Aldington and Mersham Support Group

Written Representation to PINS

December 2024

Figure 1. Areas within 300m of Battery Enclosure and at risk of Significant Likelihood of Death in the event of a battery fire (Ref Atkins Report prepared for NI HSE)

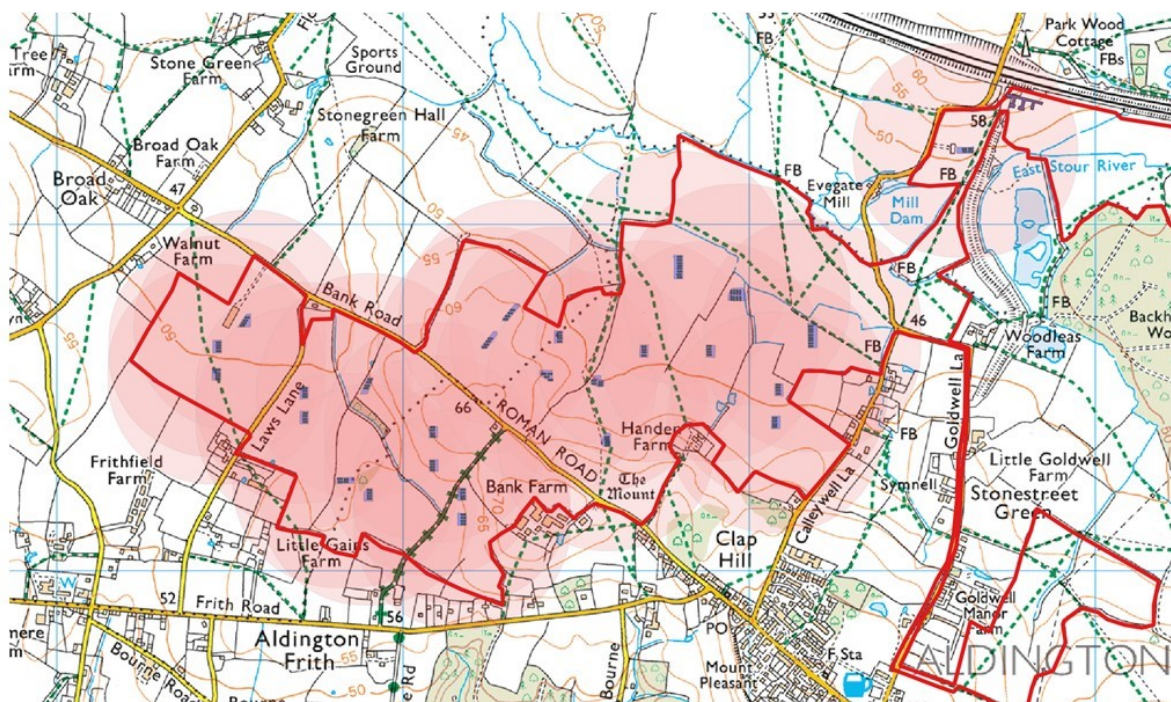
In the case of the proposed Stonestreet Green Solar development there are more than 25 residential properties (Figure 1)) within 300m of at least one battery enclosure. There will be imminent danger to life and health for people living in these houses in the event of fire, given the modelling uncertainty.

Areas shaded in pink are within 300m of one battery enclosure.

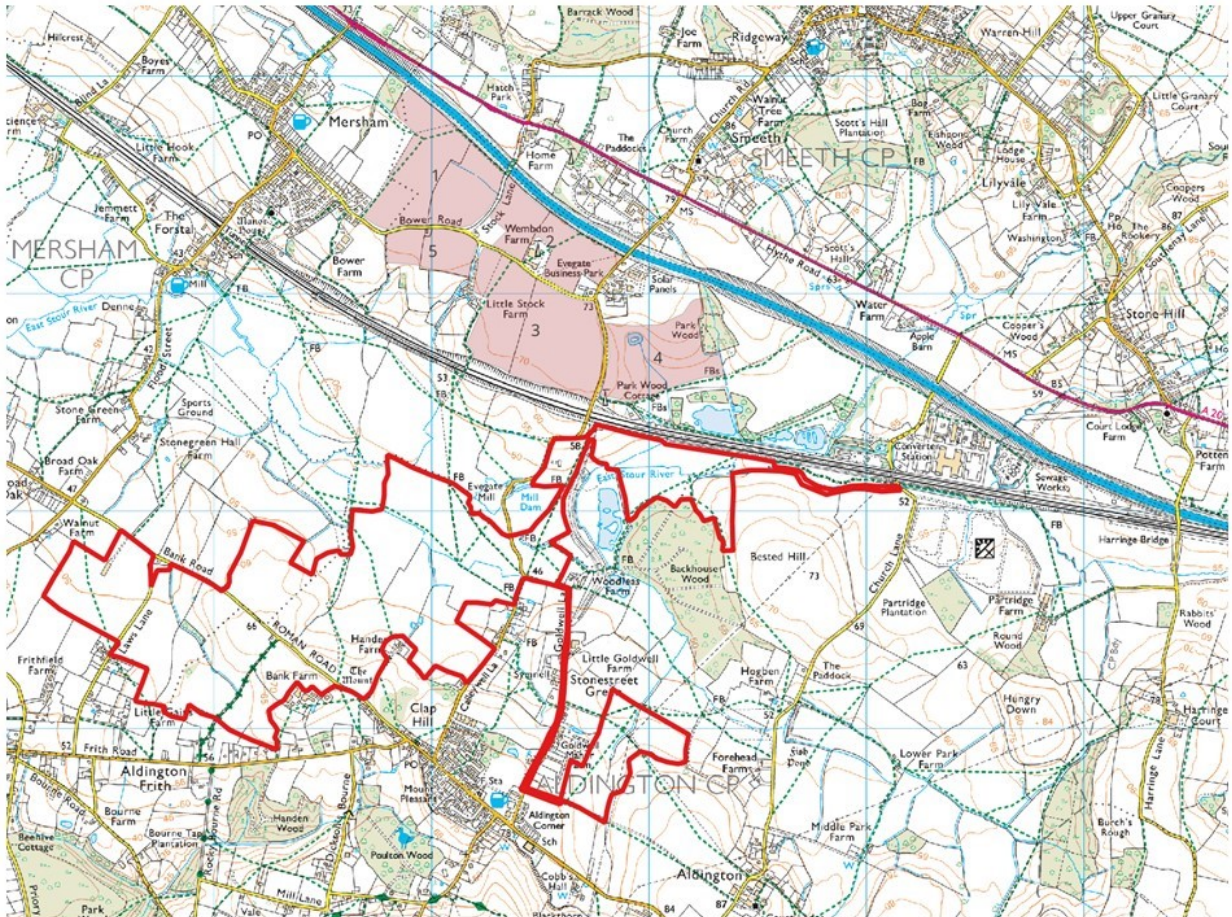
"Two parcels of land were identified to the north and south of the M20, to the north of the Site (identified in ES Volume 3, Figure 5.1: Potential Developable

Land Locations and Cumulative Schemes (Doc Ref. 5.3) as Potentially Developable Land 1 and Potentially Developable Land 2). These sites are not of a sufficient scale to deliver the Project requirements....” **Why is the fact that these areas self-evidently aren’t big enough to incorporate the whole scheme a reason for dismissing them altogether?**

“Potentially Developable Land 1 is north of the M20 motorway and as such would also involve technical challenges associated with cables having to cross the M20 carriageway”. **The M 20 is carried on a substantial bridge over Church Lane. Talk of having to “cross the M 20 carriageway” is misleading in the extreme. There is an easy cable route beneath the bridge.**

“A significant part of Potentially Developable Land 2 is subject to three planning applications”. **Yes, but why does this preclude consideration of the remaining large areas that are not affected by planning applications?**

Figure 2 Proposed area of exclusion above 58m

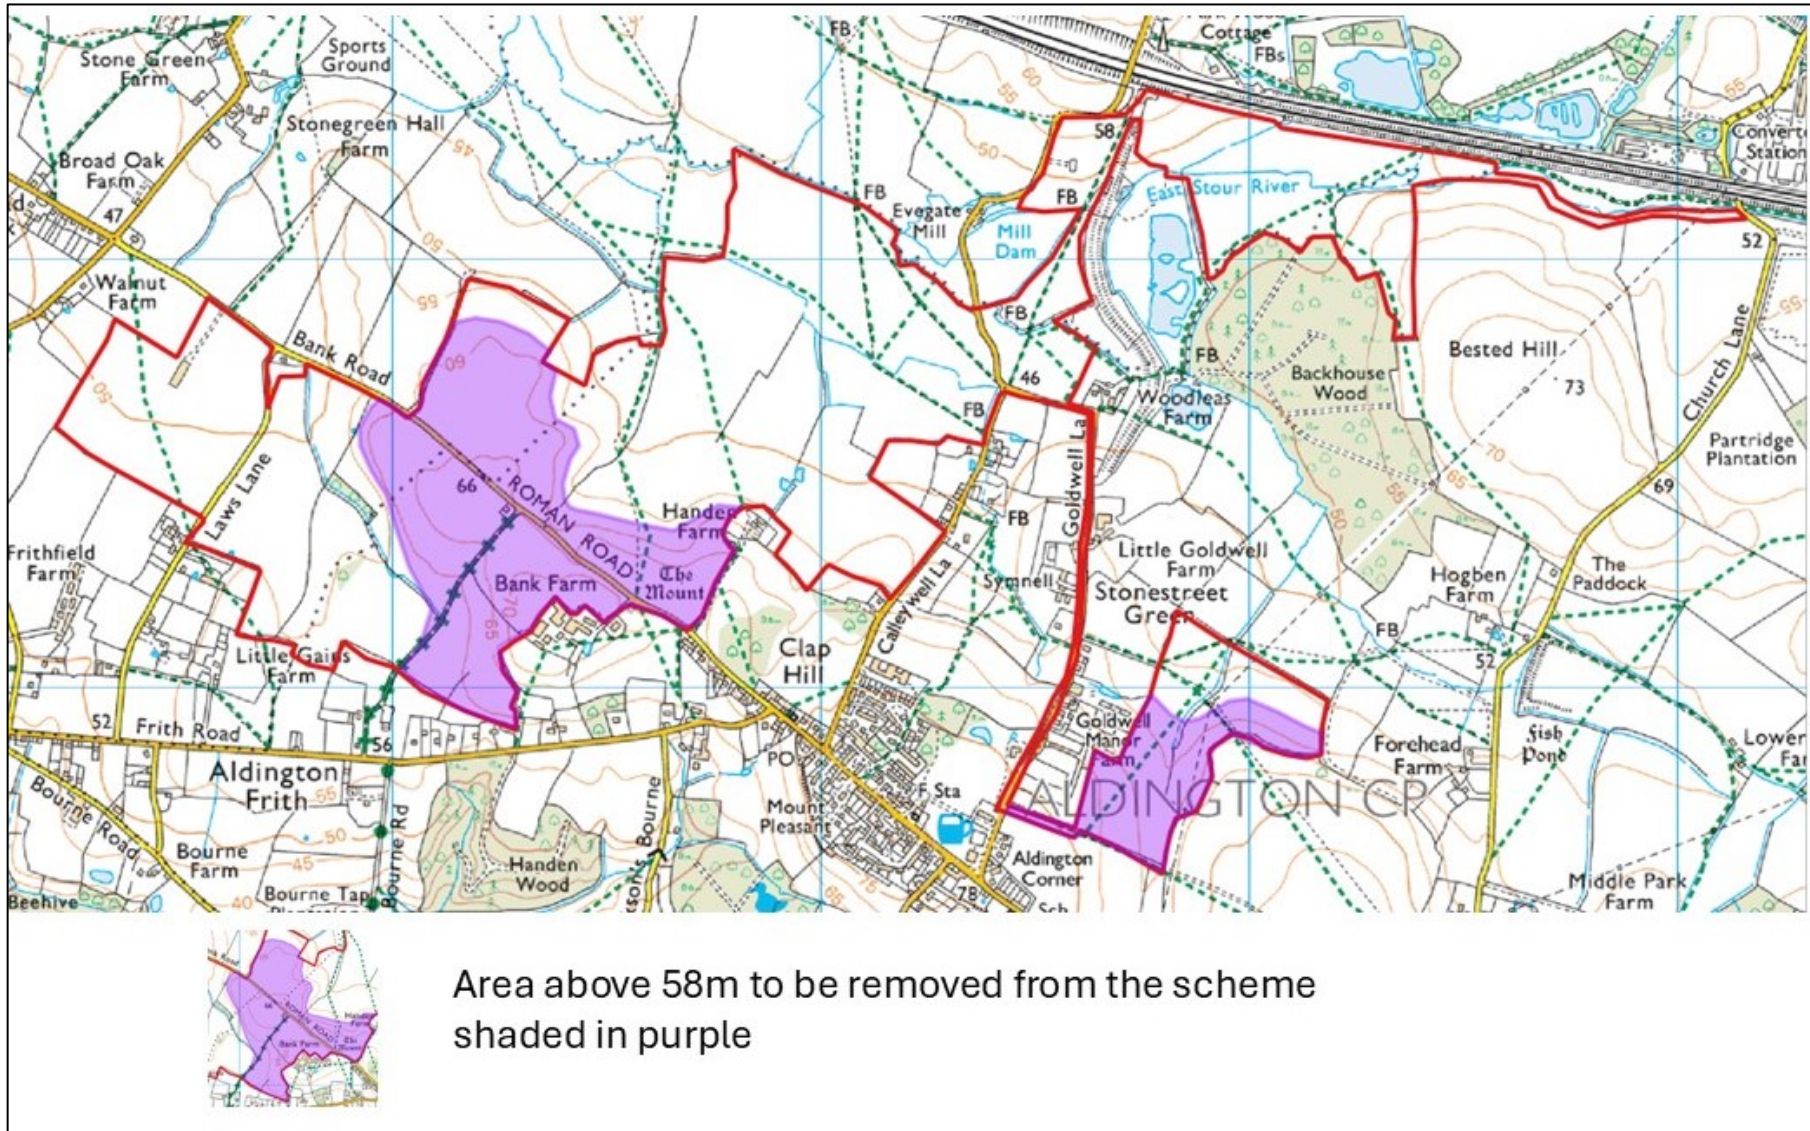
What would be the effect of removing the parts of the scheme above 58m (above mean sea level) from the Aldington Ridge (Figure 2)?

Figure 3 Agricultural Land Classification and 58m exclusion zone

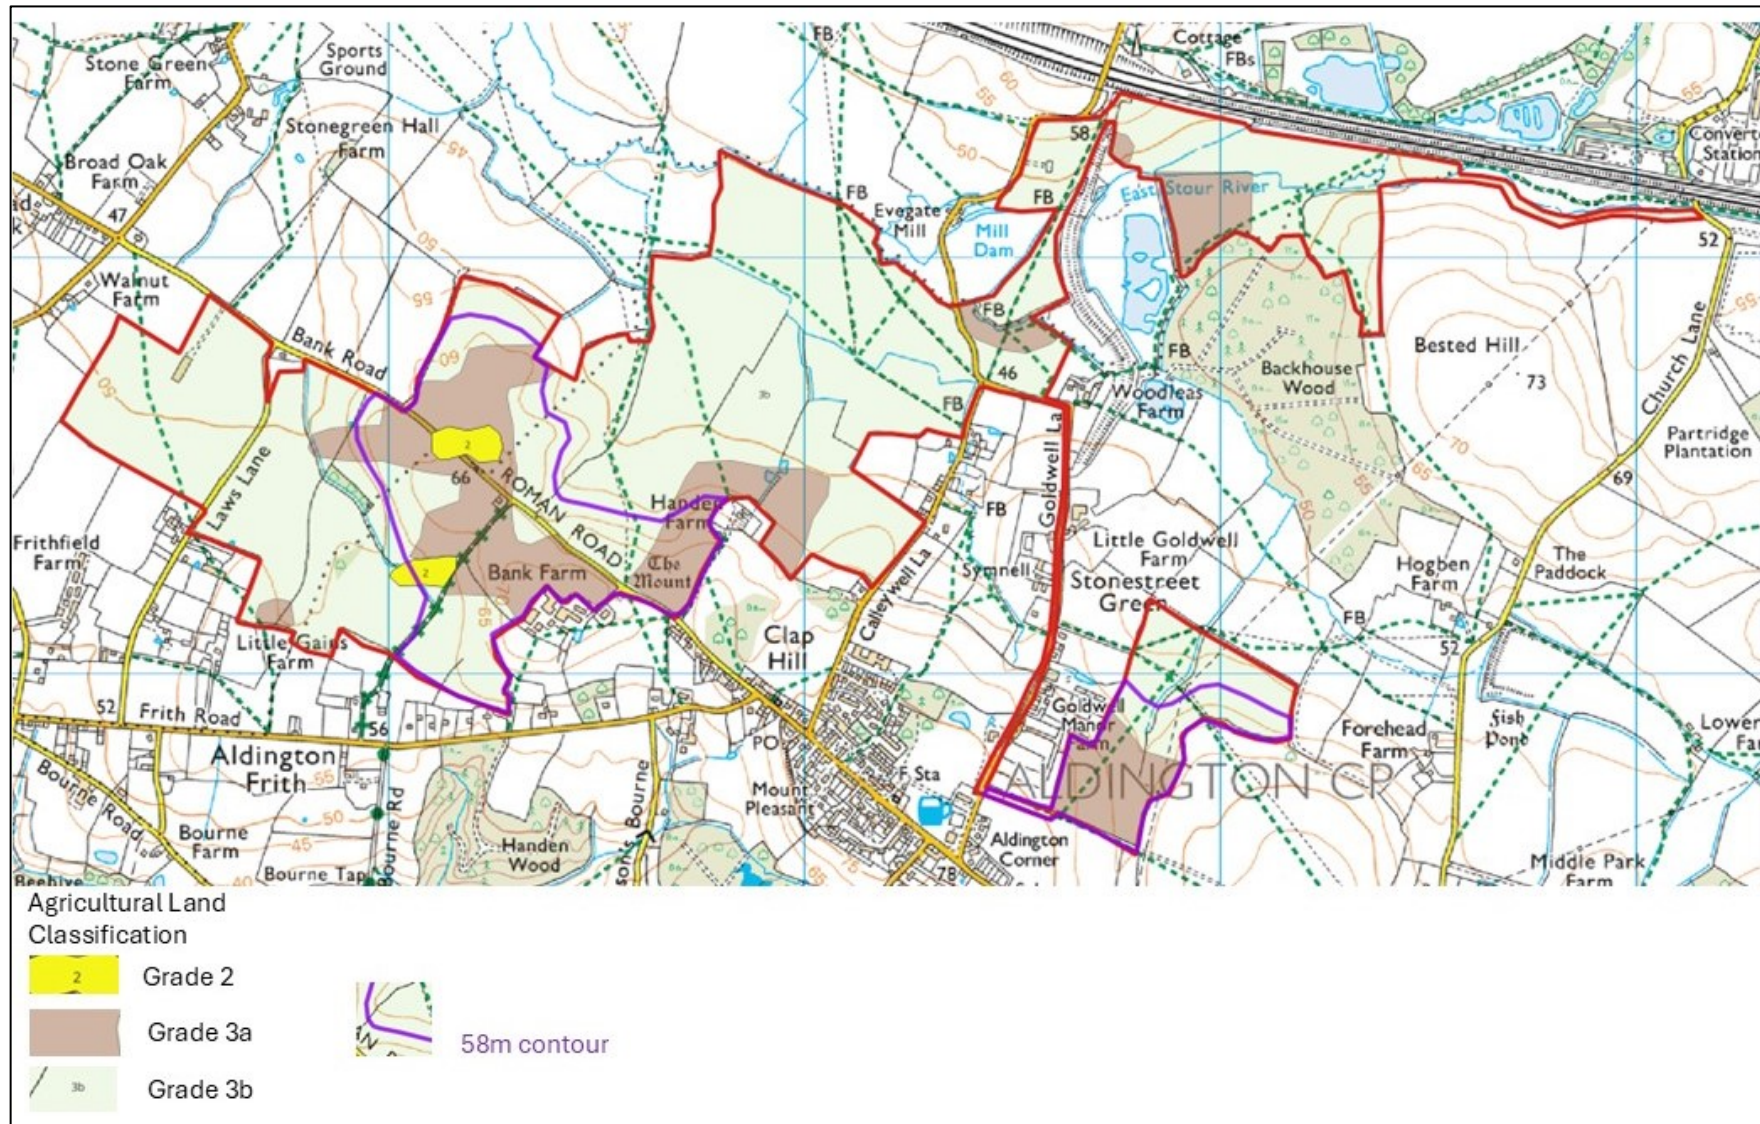
Best, Most Versatile Land – 23.4 hectares of BMV would be preserved as the vast majority of such land is located on the higher ground (Figure 3).

Figure 1 Flood Risk Map for surface water - note dark blue is high risk of flooding (Zone 3)

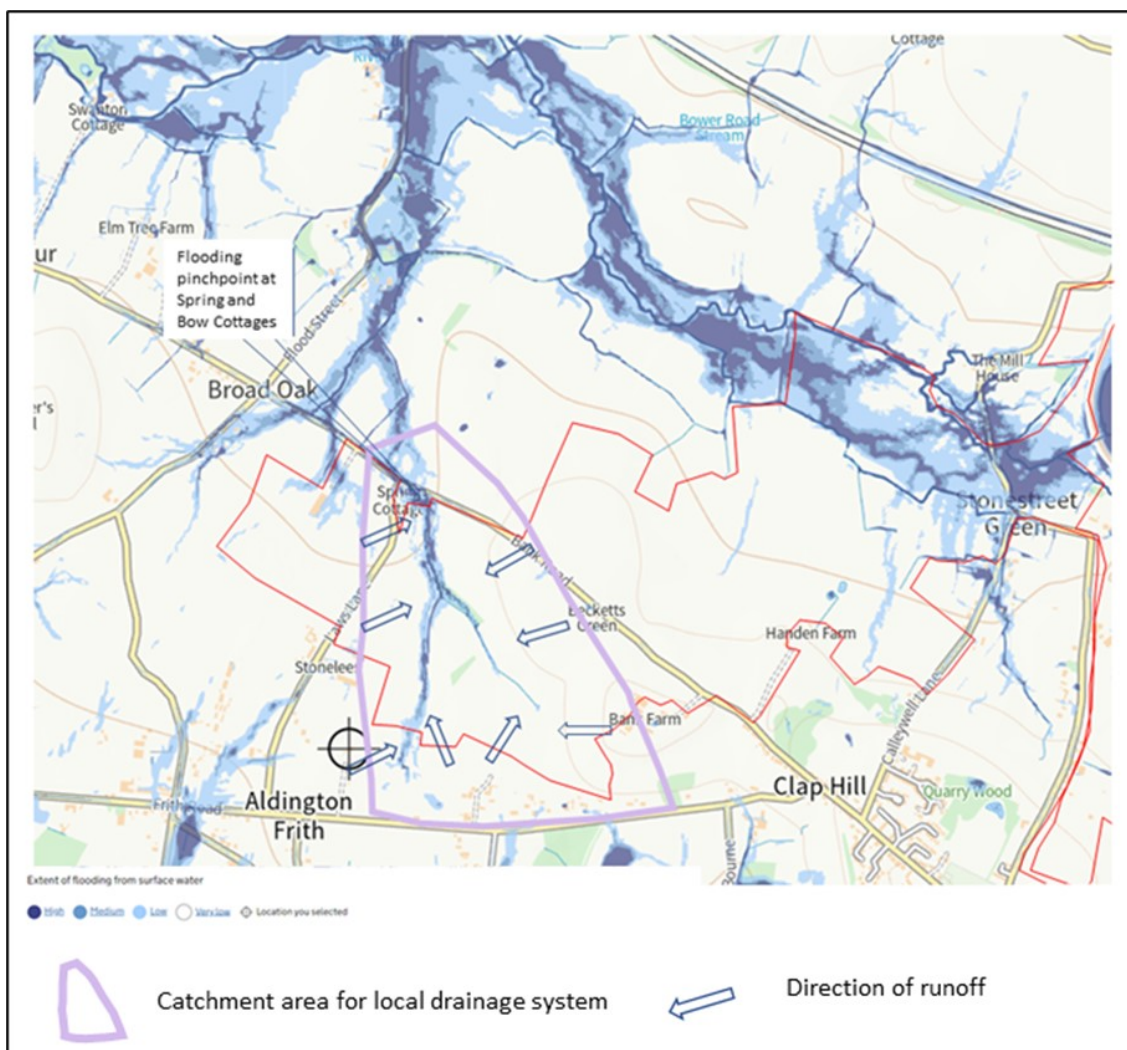
The Environment Agency risk of surface water flooding map (Figure 1) shows that there is a high risk (3.3% chance of flooding in any given year) of flooding at the NW corner of the DCO limits adjacent to Spring and Bow Cottages, located at the intersection of Laws Lane and Bank Road. The reality is that flooding occurs more frequently at these properties. Bow Cottage (Figure 2,3 & 4)) has flooded three times in the last 25 years, with more frequent events that affect the curtilage of the property occurring almost every year. In the nineties the fire brigade was called to pump out the living room and the property last flooded in 2020.

The stream/drainage system that runs adjacent to Spring and Bow Cottages collects water from a catchment area in excess of 100 acres (purple polygon in Figure 1). During high rainfall events the drainage system is overwhelmed, and serious flooding occurs at the two properties.

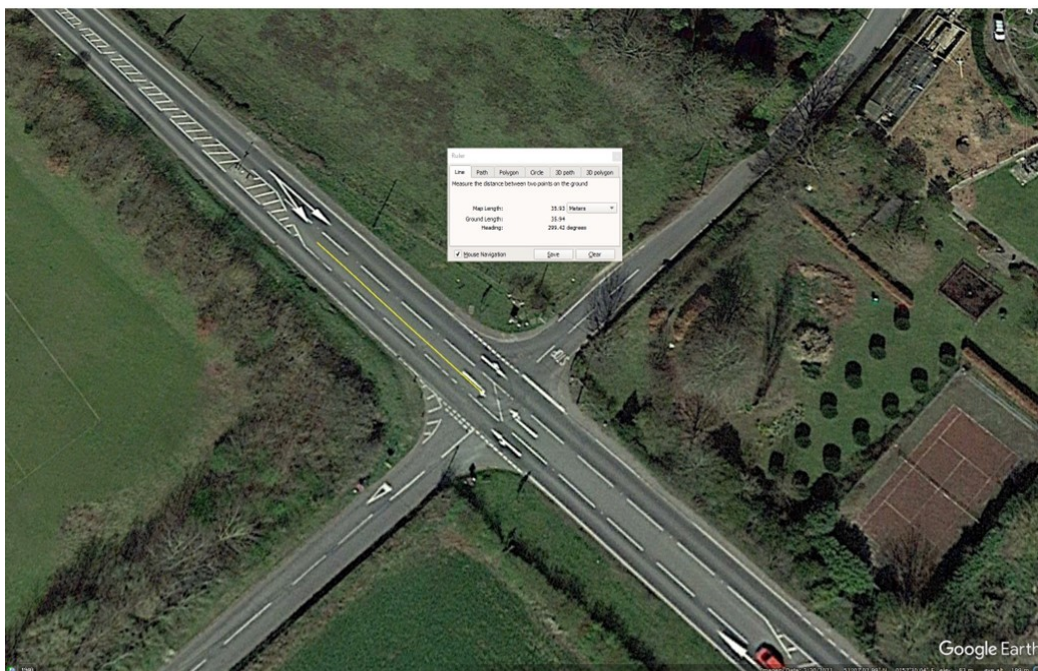
The ExA must appreciate that in a number of places the metalled highway is as narrow as **4m**. How will it be possible for the Applicant’s articulated wagons (that are so large that they need to have an escort to navigate the sharp bend in the lane) manage to pass other HGVs that will remain free to use the lane at the same time?

We doubt that Stop/go/temporary traffic lights are going to work when the 2m wide trench is being installed (on varying alignments to avoid services in the road). How can this work on a “half and half” basis when there are sections of the lane where there is insufficient space to allow even small vehicles to get past each other alongside such

excavations (and safe working areas) let alone HGVs for which the standard width in the UK is **2.55m**?
